DOCUMENT CHANGE REQUEST

DCR number 489 Changes required for: General
Date: 2009/04/14 Date sent: 2009/04/14
Status: IMPLEMENTED

Title: Transistors Low Power NPN, based on type 2N3700

Number: 5201/004 Issue: 3

1.6.1 Metal Can Package (TO-18) - 3 lead

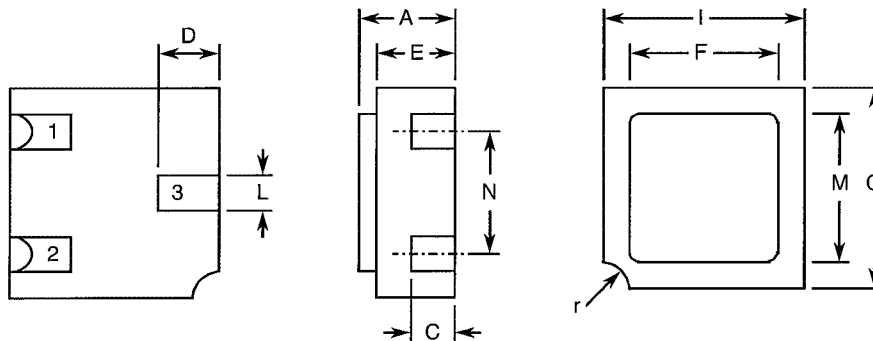
Note addition of horizontal lines

1.6.2 Chip Carrier Package (CCP) - 3 terminal

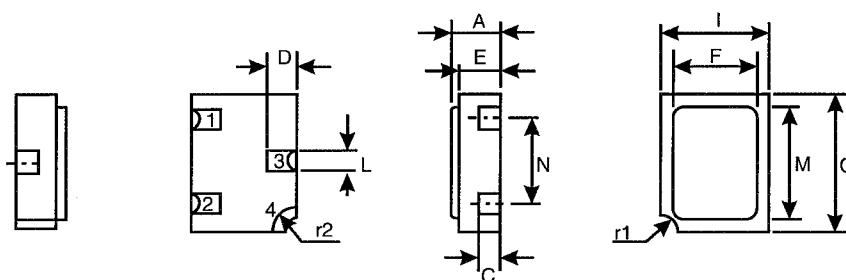
Note addition of horizontal lines
